V2500-A5/D5 SERIES PROPULSION SYSTEM NON-MODIFICATION SERVICE BULLETIN

This document transmits the Initial Issue of Service Bulletin EV2500-72-0428

V2500-ENG-72-0428

**NON MODIFICATION SERVICE BULLETIN – ENGINE – HPT STAGE 2 BLADE INSPECTION FOR SURFACE
IMPERFECTIONS ON AIRFOIL****1. Planning Information****A. Effectivity****(1) Airbus A319**

TYPICAL HPT STAGE 2 SUSPECT BLADE
Figure 1

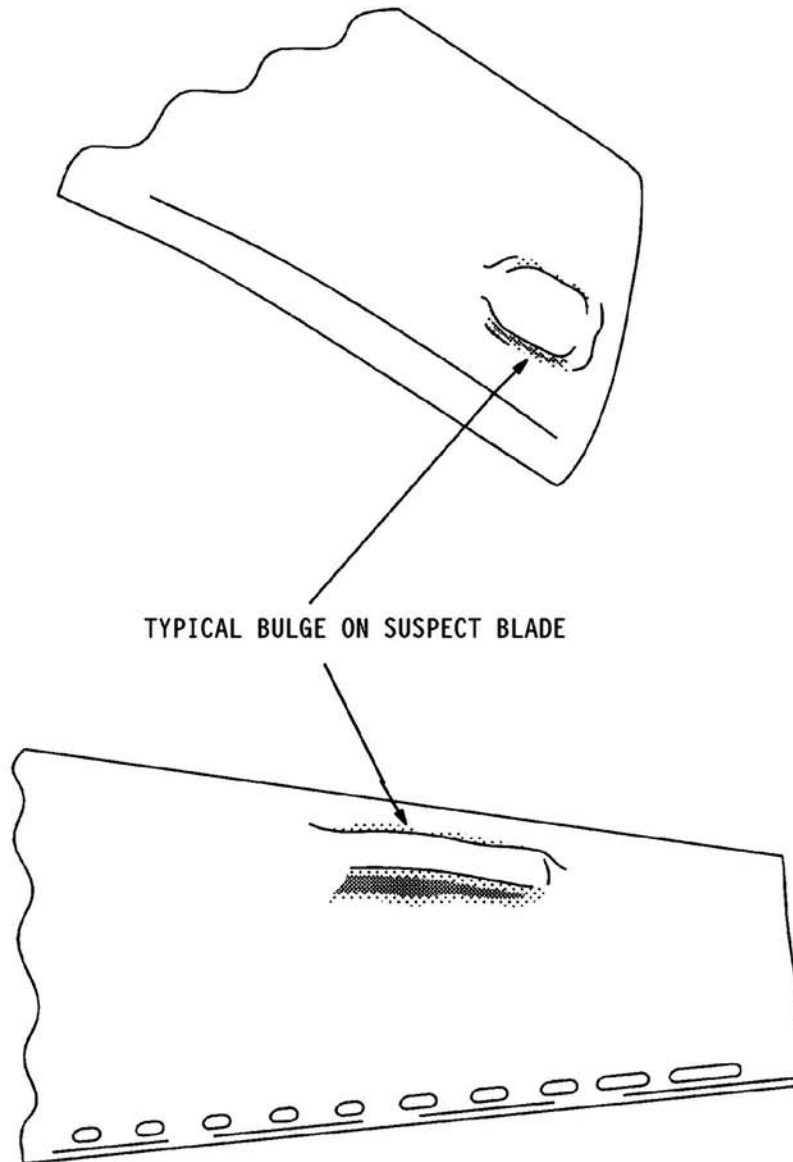
- (a) A tool (IAE2P16497), which will have a typical surface imperfection will be provided to each shop as an example of what to inspect for. The surface imperfections will vary in size, location and shape and the tool is only a typical example.

- (b) Inspect blades for surface imperfections with a visual inspection and carefully examine parts with hand for raised material. Run fingers over the concave and convex sides of the airfoil feeling for protrusions on the airfoil. The surface imperfection is an area of the airfoil on either the concave or convex side, which has a slight bulge or bump. The typical location for the slight bulge is from 50% span to the tip, on the concave and convex sides. See Figure 1.
- (c) If blades with surface imperfections are found they must be replaced. IAE Technical Services must also be notified via field representative.

- (a) Replace all blades with surface imperfections in accordance with the Engine Manual. See reference 3. and 4. , Task 72-45-30-040-001-C00)
